**STAFF REPORT
WEST ALLIS PLAN COMMISSION
Wednesday, March 22, 2023
6:00 PM**

6. **Site, Landscaping, and Architectural Design Review for LA Pub & Grill, a proposed Tavern, at 5832 W. Lincoln Ave. (Tax Key No. 474-0402-000)**

1 PROPOSED SITE PLAN ← N

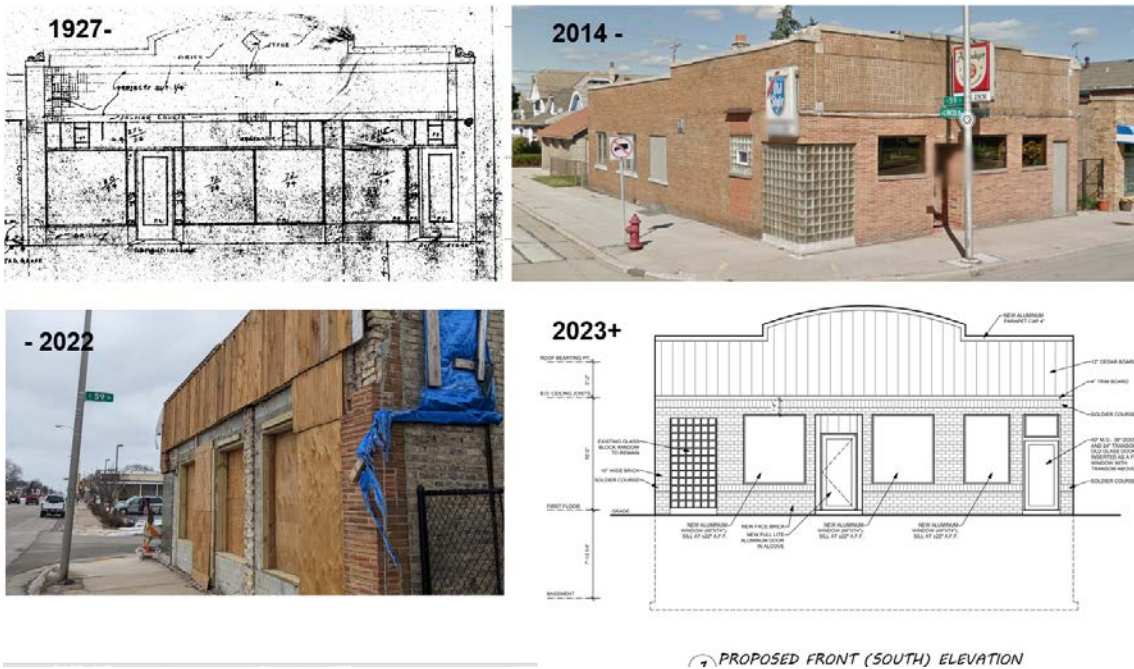
Staff is recommending the site plan specify site improvements like chain link fence removal areas, new fence areas, fence style and height, refuse area and screening details. Provide a basic table chair layout of the outdoor area (number of seats) and any screening considerations.

2. Exterior lighting plans. Show exterior lighting details of the proposed location and fixture type on the plans.
3. Revised site and landscaping plan to be submitted to the Planning and Zoning Office to show the following: (a) specify site improvements like chain link fence removal areas, new fence areas, fence style and height, refuse area and screening details; (b) Provide a basic table chair layout of the outdoor area (number of seats) and any screening considerations.
